103	10/25/10	CHANGE ORDER #87
38	12/23/11	ASI#131

CHILDREN'S HOSPITAL
OF ORANGE COUNTY

FIFTH FLOOR INTERIOR
ELEVATIONS

A9.5B

A6 TYPICAL PATIENT ROOM (5.124)
3/8" = 1'-0"

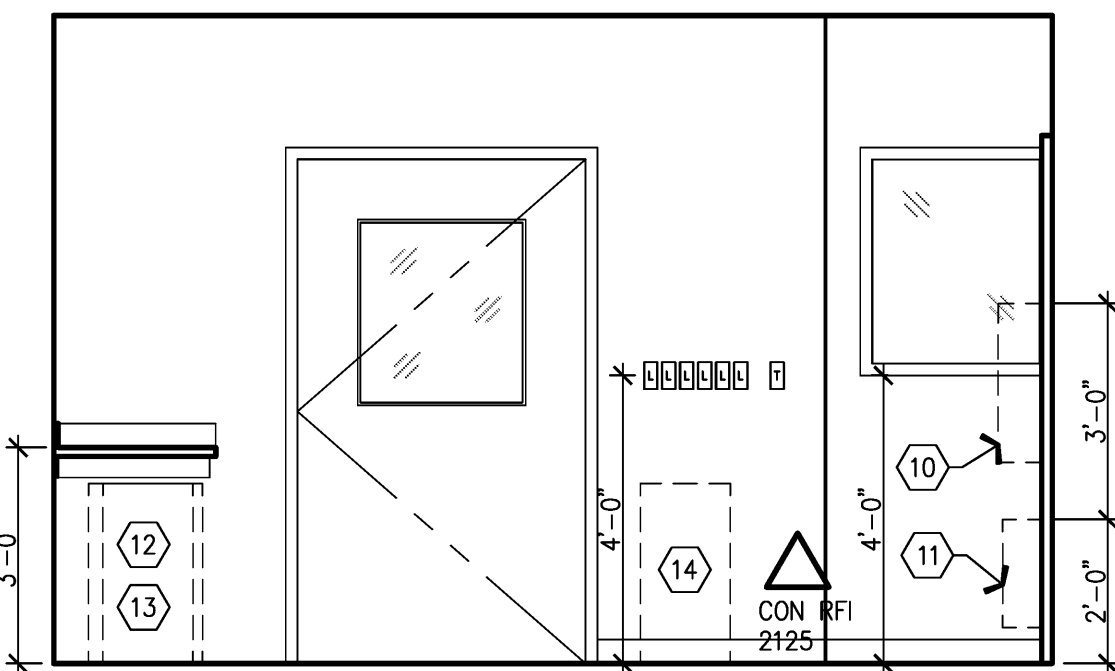
RFI 1824
Head wall to be PL-1

RFI 2505
Headwall configuration

RFI 2962
Field headwall 1 1/4" from face
of drywall to face of p-lam
